ZHL-2-8+ PCN Report

AN-60-075

ORIGINAL PART: ZHL-2-8

REPLACEMENT PART: ZHL-2-8+

CASE STYLE

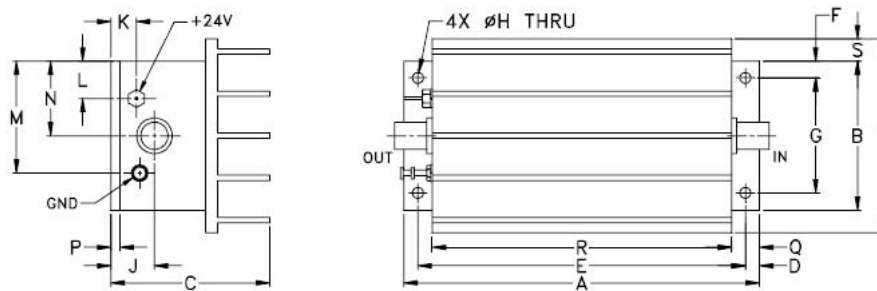
CASE STYLE: T34, No change

COMPARISON PERFORMANCE CURVES^a: T_{AMB}=25°C

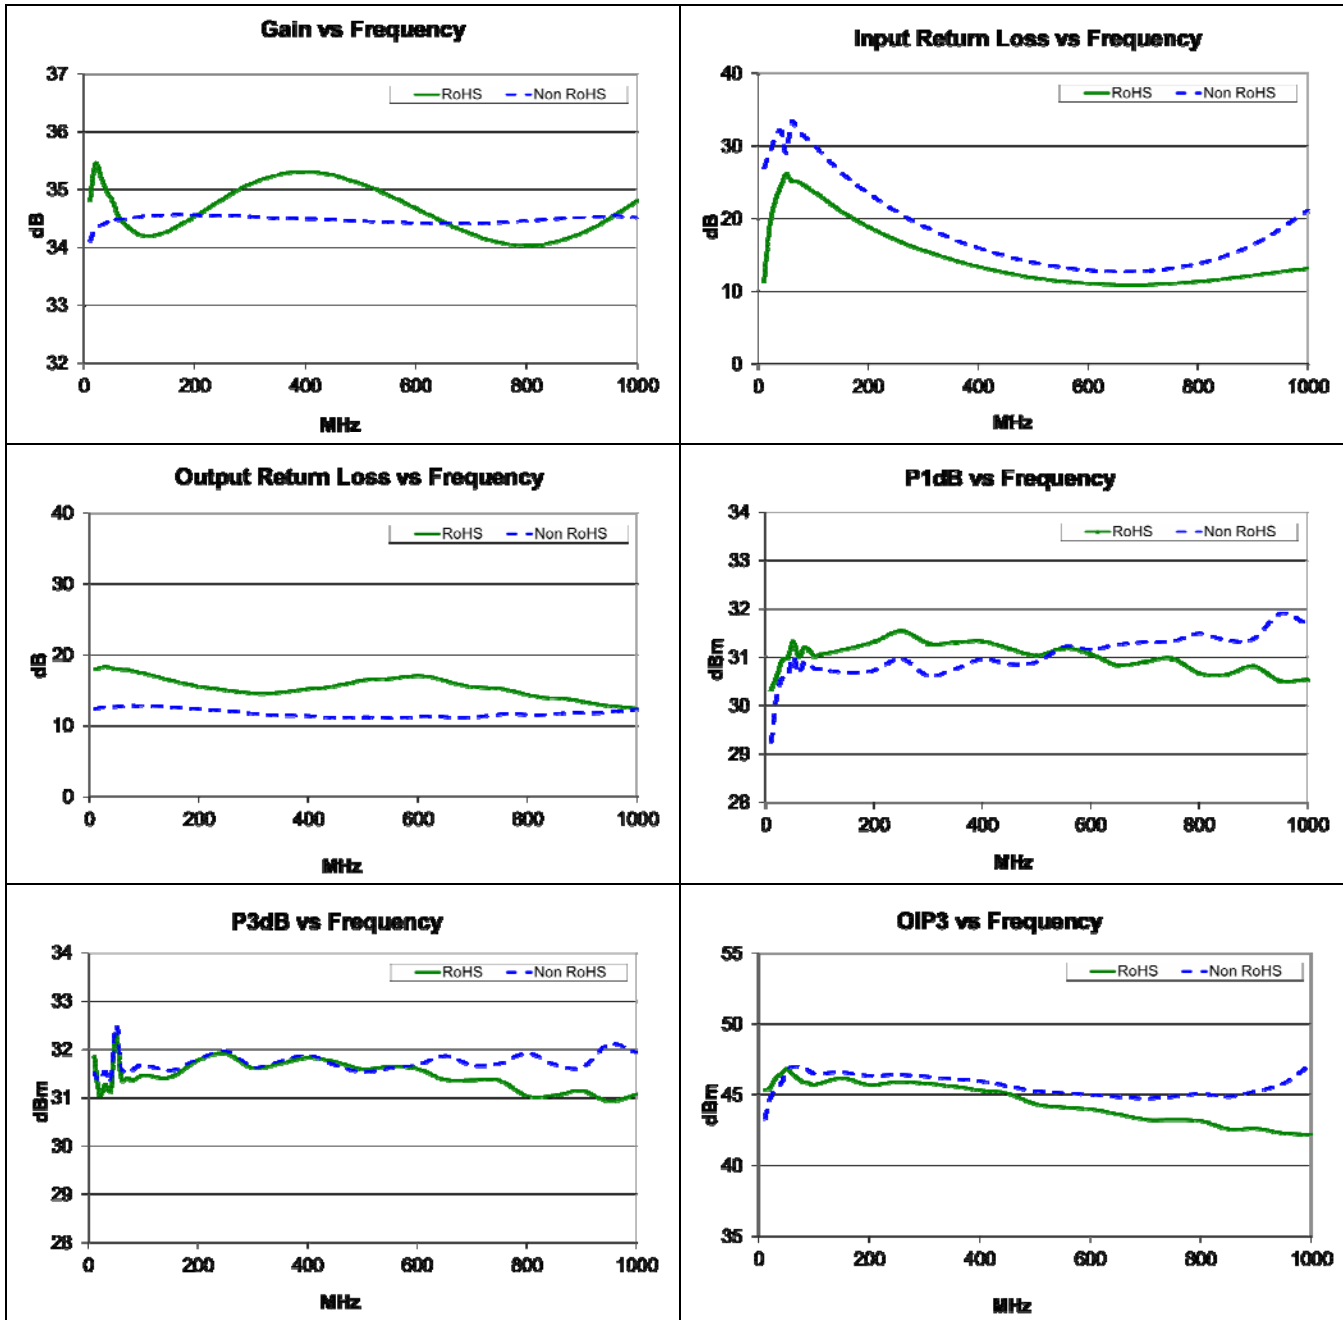
3) TYPICAL PERFORMANCE COMPARISON_a: T_{AMB}=25°C

Parameter	Freq (MHz)	Non RoHS (ZHL-2-8)		RoHS (ZHL-2-8+)	
		Min	Max	Min	Max
Gain (dB)	10-1000	34.11	34.56	33.46	35.45
Gain Flatness (dB)	10-1000	-----	+/-0.23	-----	+/-0.77
Input VSWR (:1)	10-1000	-----	1.59	-----	1.79
Output VSWR (:1)	10-1000	-----	1.78	-----	1.64
Pout 1dB (dBm)	10-1000	29.25	-----	30.35	-----
Pout 3dB (dBm)	10-1000	31.33	-----	30.93	-----
OIP3 (dBm)	10-1000	44.35	-----	42.17	-----
Noise Figure (dB)	10-1000	-----	5.44	-----	7.41
DC Voltage (V)	-----	-----	24	-----	24
Supply Current (A)	-----	-----	0.54	-----	0.58

COMPARISON PERFORMANCE CURVES^a (Continued):

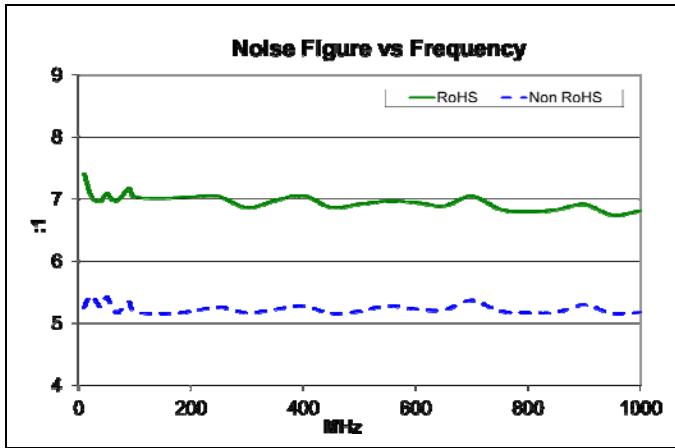
- 1) No change in FIT and FORM
- 2) Functional Changes as follows:

Parameter	Original Part, ZHL-2-8	Replacement Part, ZHL-2-8+
Gain	31dB min, 35dB typ	31dB min, 34dB typ, 39dB max
Gain Flatness	+/-1dB max	+/-1.3dB max, +/-0.8dB typ
P1dB	29dBm min	28dBm min, 29dBm typ
P3dB	N/A	29dBm min, 30dBm typ
Noise Figure	10dB typ	7dB typ
OIP3	38dBm typ	42dBm typ
Supply Current	0.6A max	0.7A max
